2025 GROUP B PROPOSED CHANGES TO THE I-CODES

2025 GROUP B – PROPOSED CHANGES TO THE INTERNATIONAL EXTINGUISHING BUILDING CODE

EXISTING BUILDING CODE COMMITTEE

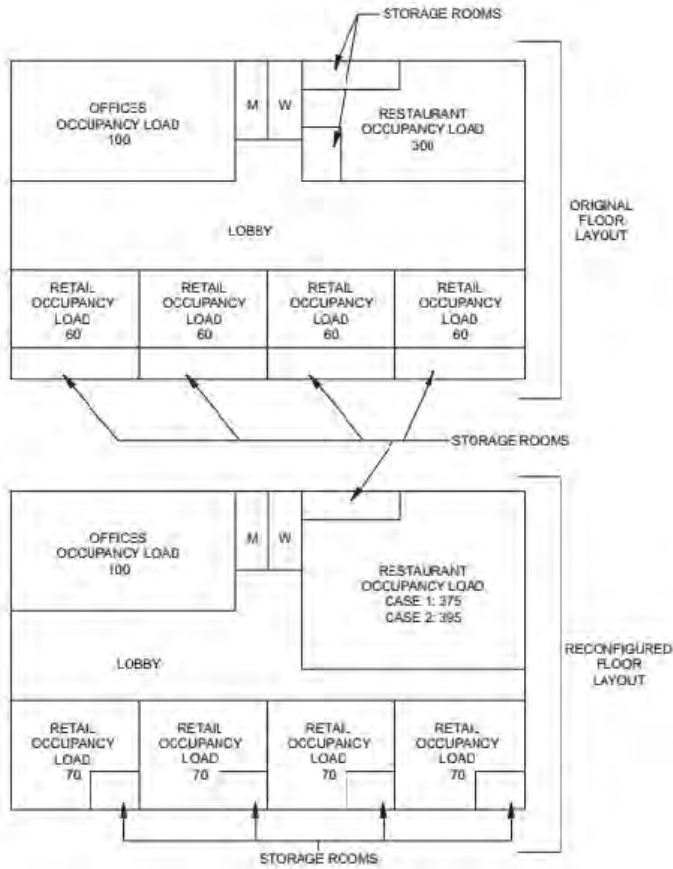
~~**Exception:** Only where the occupant load of the story is increased by more than 20 percent, plumbing fixtures for the story shall be provided in quantities specified in the International Plumbing Code based on the increased occupant load.~~

Reason: This code change is to undo the inadvertently substantive change when the plumbing requirements in the alterations section of the code (Section 809 in the 2018 IEBC and prior) were moved to the exception for plumbing fixtures in the change of occupancy section during the 2021 code cycle (See EB92-19): <https://www.cdpassess.com/proposal/5439/8306/preview/>.

This provision allows existing plumbing fixtures to remain unchanged as long as renovations result in an occupant load increase of no more than 20% of the current load. During the 2021 code change cycle, proponents of EB92-19 argued that a 20% occupant load increase qualifies as a change of occupancy. They suggested relocating this provision from the Level 2 Alteration section to the Change of Occupancy chapter as an exception.

[BS] FIGURE A304.3.1(1) SILL PLATE BOLTING TO EXISTING FOUNDATION^{a, b}

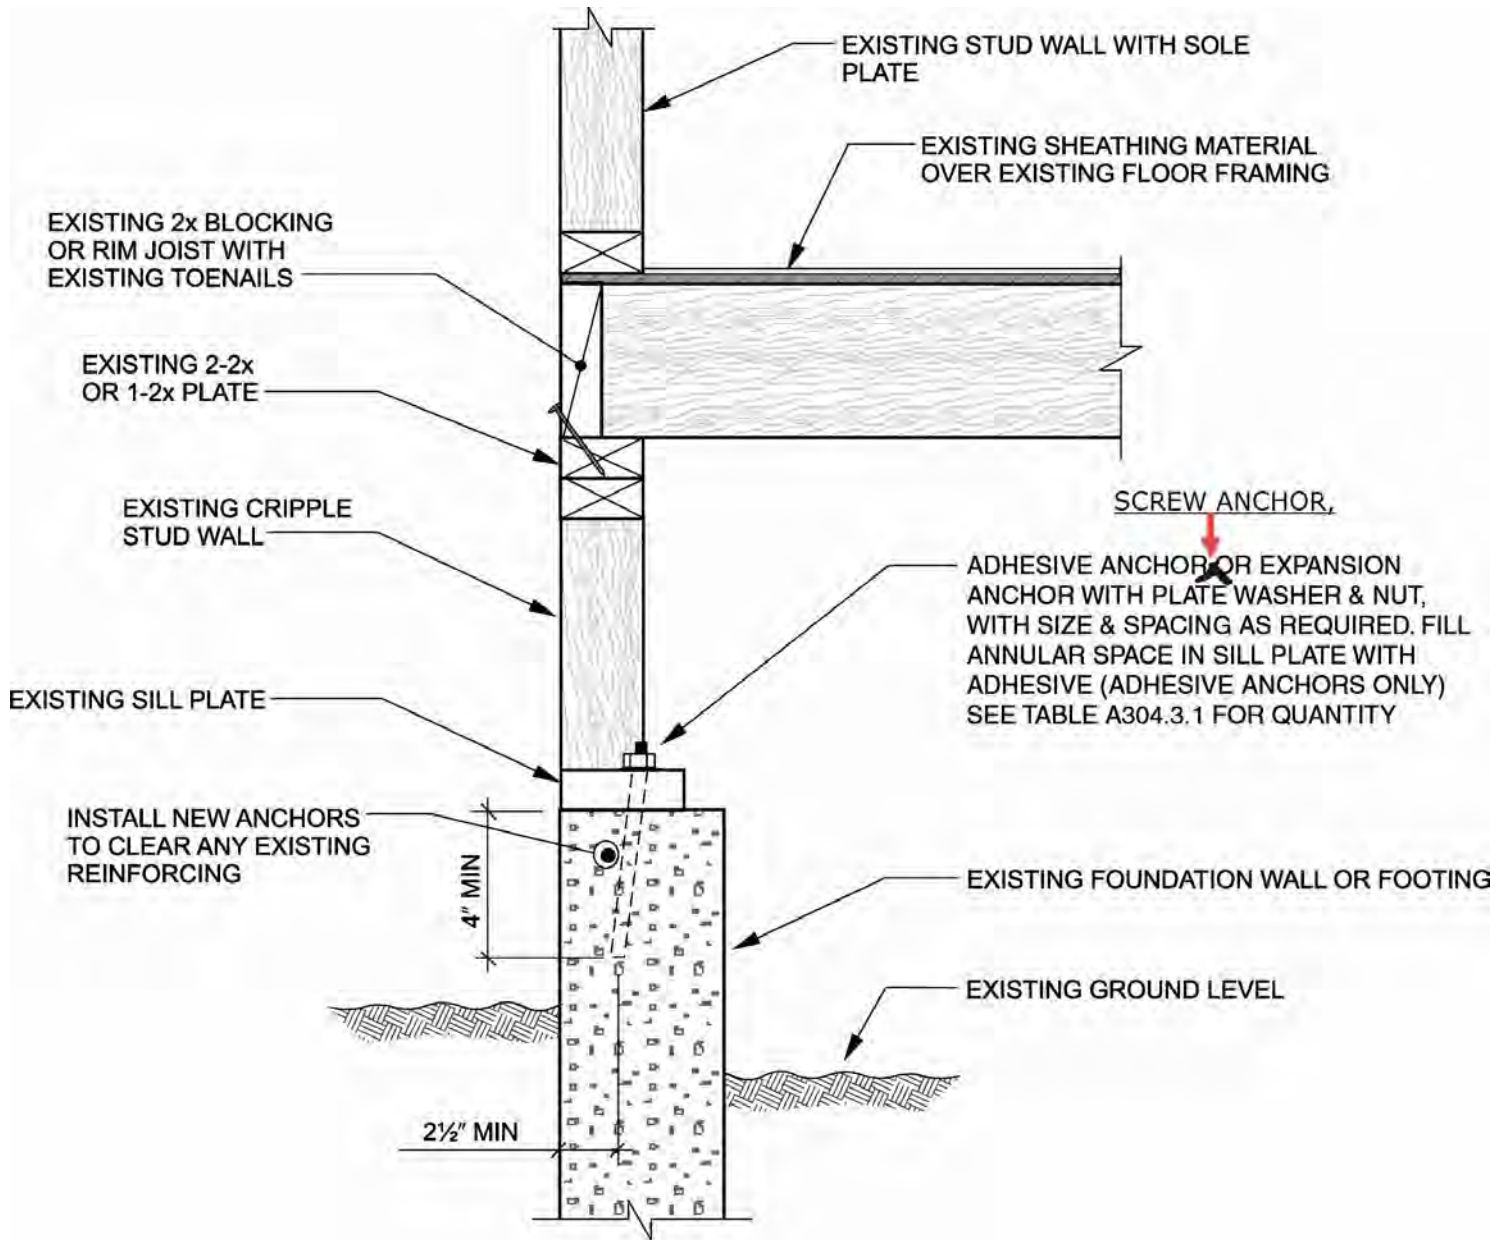
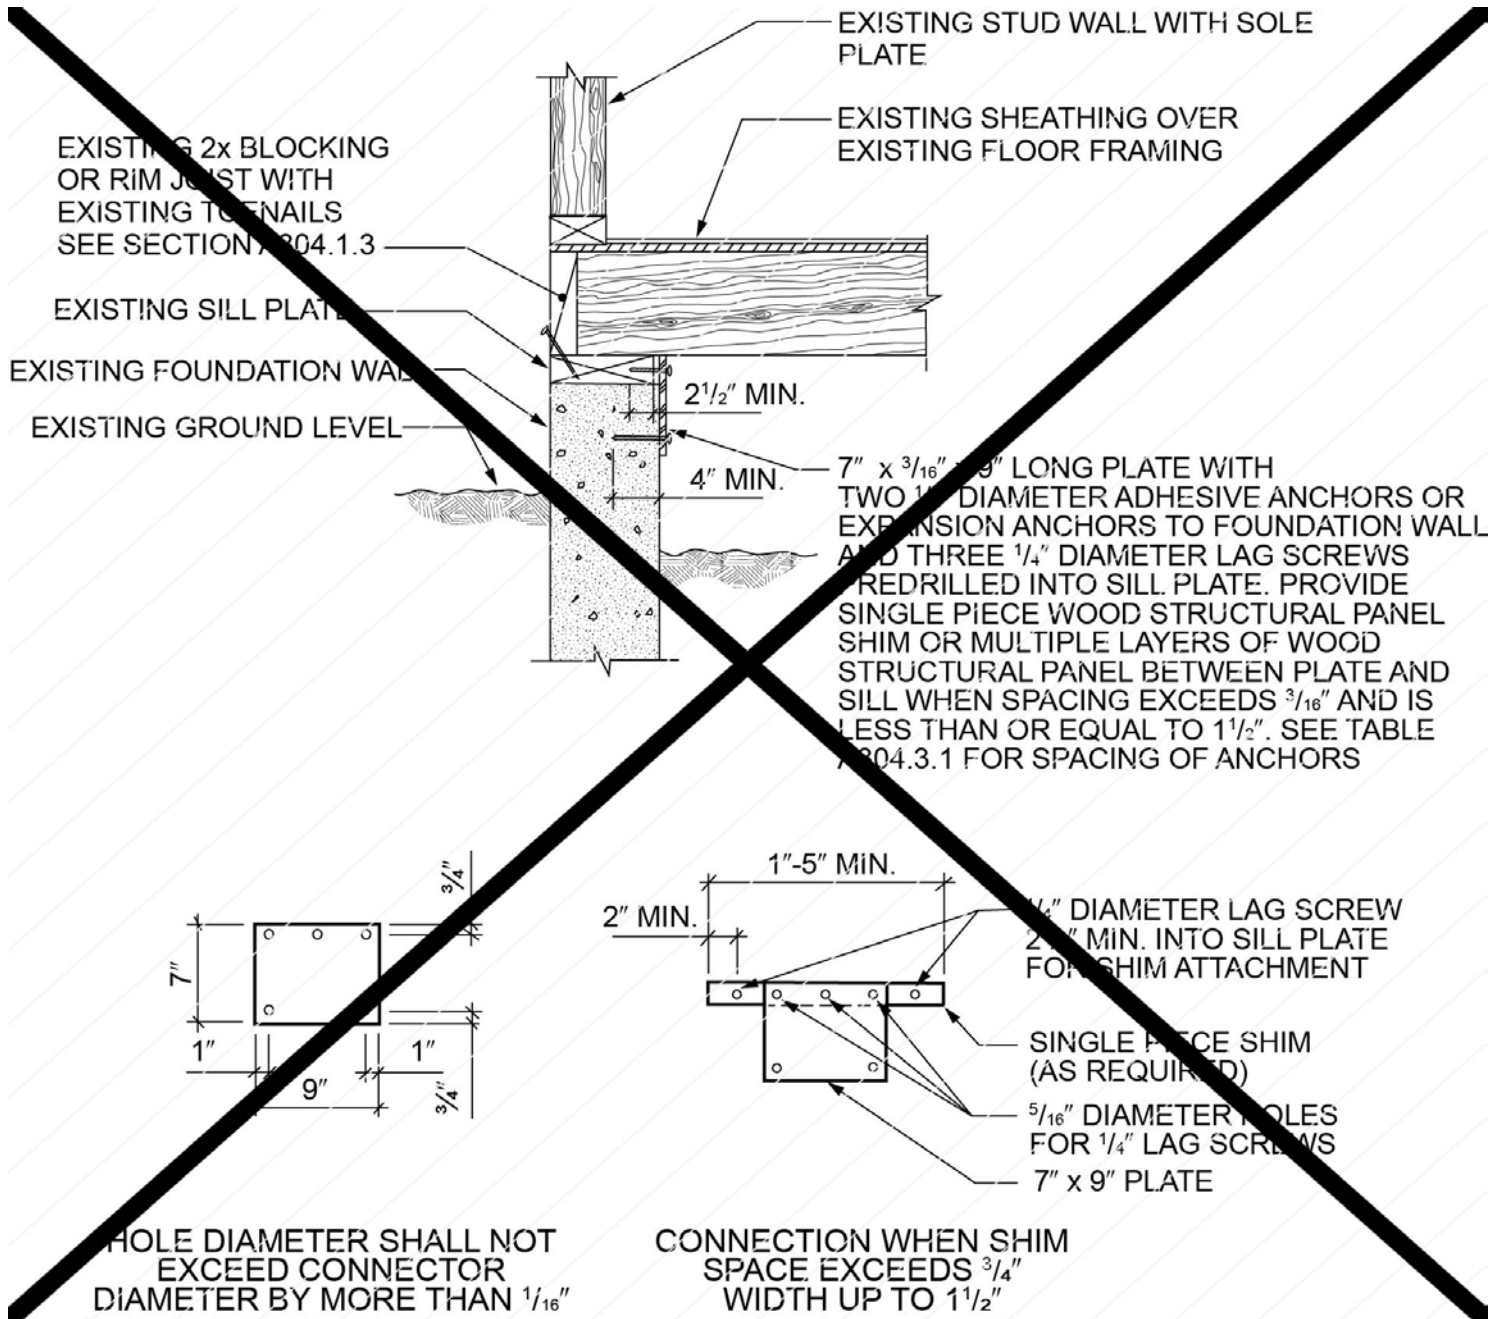
Delete and substitute as follows:

$\frac{1}{2}$ -inch anchor or bolt—3 inches \times 3 inches \times 0.229 inch minimum.

$\frac{5}{8}$ -inch anchor or bolt—3 inches \times 3 inches \times 0.229 inch minimum.

[BS] FIGURE A304.3.1(2) ALTERNATIVE SILL PLATE ANCHORING IN EXISTING FOUNDATION—WITHOUT CRIPPLE WALLS AND FLOOR FRAMING NOT PARALLEL TO FOUNDATIONS^{a, b}

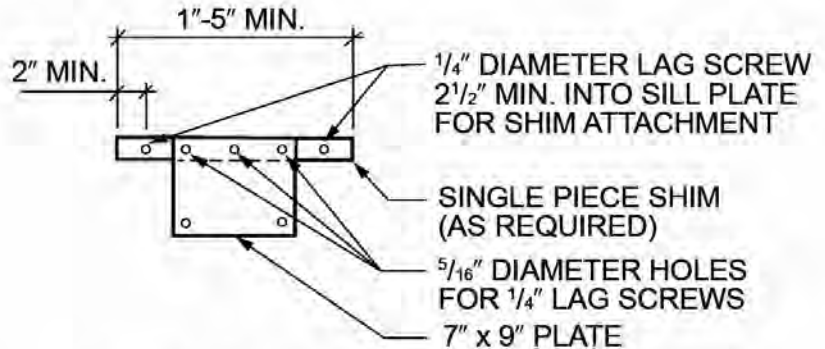
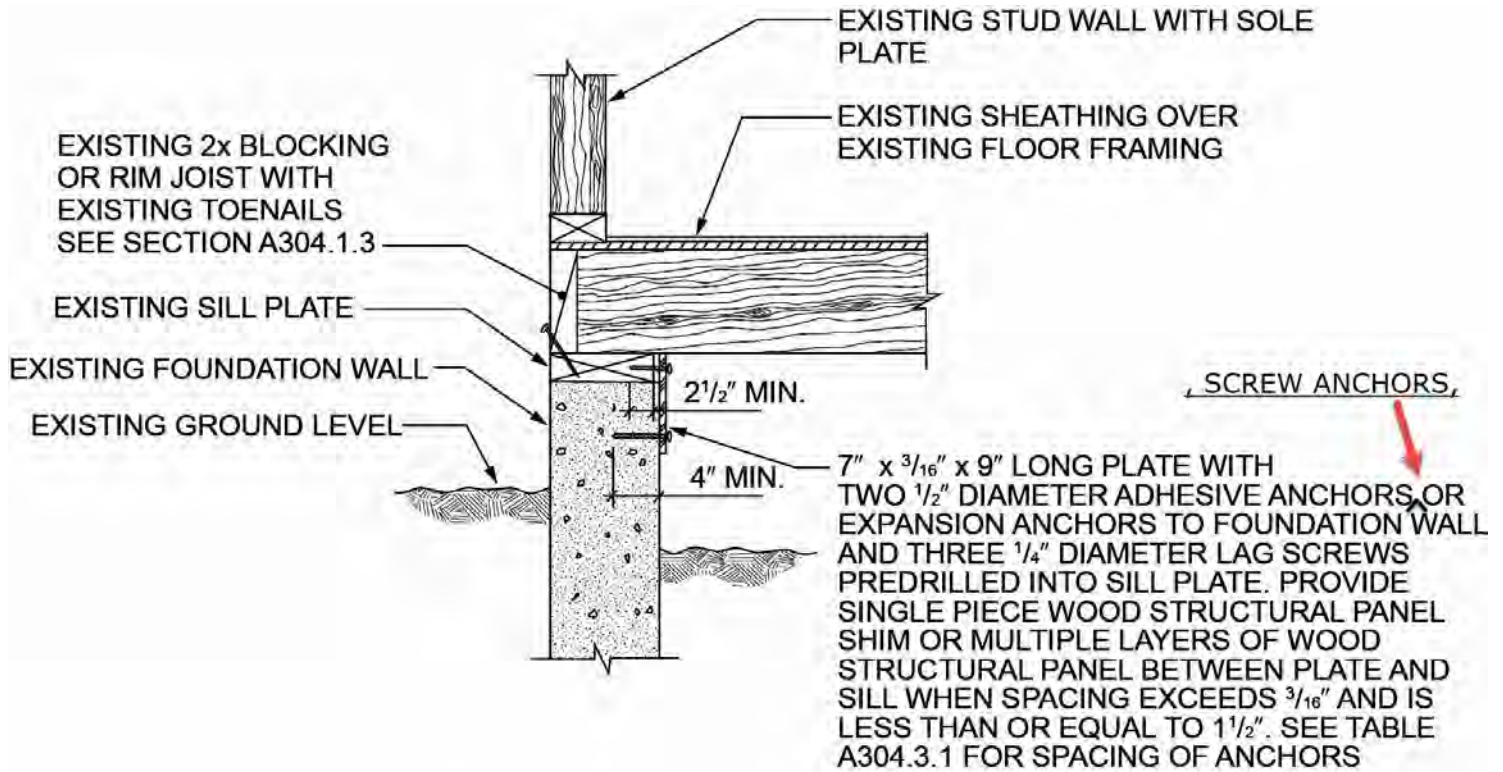
- a. If shim space exceeds 1 1/2 inches, alternative details will be required.
- b. Where required, single piece shim shall be naturally durable wood or preservative treated wood. If preservative treated wood is used, it shall be isolated from the foundation system with a moisture barrier.

HOLE DIAMETER SHALL NOT EXCEED CONNECTOR DIAMETER BY MORE THAN 1/16"
